CITY OF SAN ANTONIO

Re: Irvin 182.03 Acre Tract

MDP # 867

The City Staff Development Review Committee has reviewed Irvin 182.03 acre Tract Master Development Plan **M.D.P. # 867**. Please find enclosed a signed copy for your files. Your plan was accepted however please note the following:

IRVIN 182.03 ACRE TRACT MASTER DEVELOPMENT PLAN

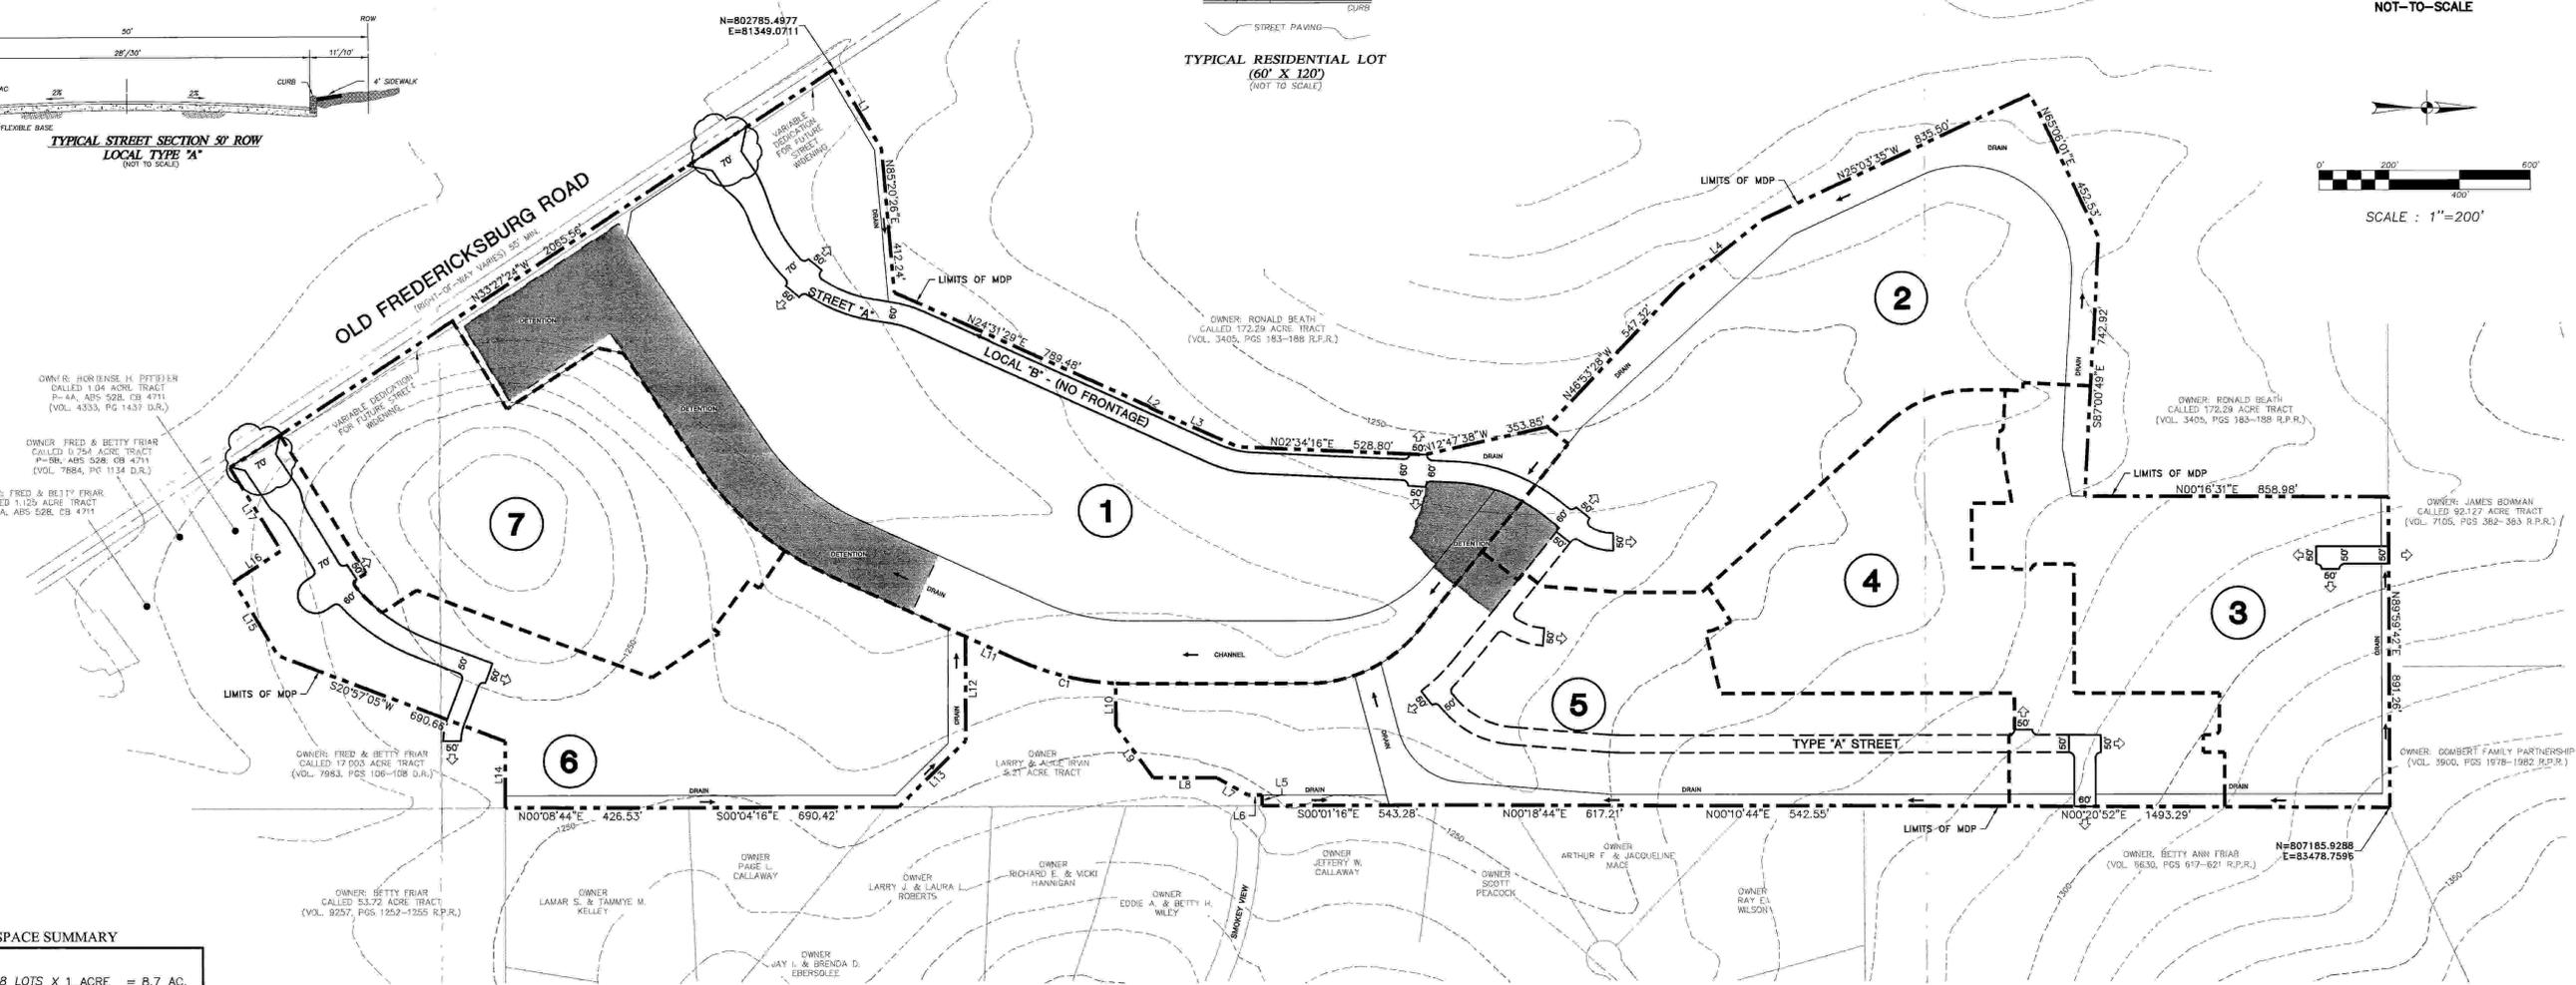
- In consideration of public safety and convenience, excessive grades by reason of topography should be avoided in street layouts and arrangements.
- Any access and R.O.W. issues along state facilities will need to be resolved with the **Texas Department of Transportation (TXDOT)**. For information about these requirements you can contact TXDOT at 615-5814.

- Traffic Impact Analysis states the following requirements and on-site improvements are necessary and shall be provided by the developer, on and before the completion date of 2008:

- All roadways shall follow Table 506-7, Functional Classification System Description and shall comply with UDC §35-502(a)(9).
 - All access roadways shall provide clear sight distance on all existing and proposed roadways in order to provide adequate obstruction free viewing distance for approaching traffic. All signage, landscaping, and improvements shall be selected and located so as to not block these clear sight distance areas.

- The developer shall be responsible for providing right-turn deceleration lanes as well as left turn lanes, with storage lengths and bay taper as it relates to the submitted TIA traffic counts, (Uniform Development Code (UDC) – 35-502(a)(7), subsection C.

- No layout for a detailed internal street network has been provided. The Traffic Impact Analysis Division review is in no way a review of an internal street network. Streets reserve the right to make further comments should a detailed internal street network be provided prior to Planning Commission approval. UDC 35-506 will be implemented at the time of platting.

- Access from Old Fredericksburg at the north most entrance will require a southbound left turn and a northbound right turn lane.
 - Access through the adjacent Lost Creek Subdivision to Ralph Fair Road shall be secured prior to approval of any plat submitted for the Irvin Tract Subdivision

- All traffic controls shall be warranted as per the Texas Manual on Unified Control Devices and approved by Bexar County
 - It is understood that this MDP is a conceptual plan and all regulations will be addressed at time of platting.

- Bexar County reserves the right to address Driveways, Street Design, Sight Distance, ADA requirements, Drainage and Flood Plain issues at the time of platting.

- It will be expected that you will plat all of the property depicted in your Master Development Plan (M.D.P.) to include floodplains, drainage areas and open space.
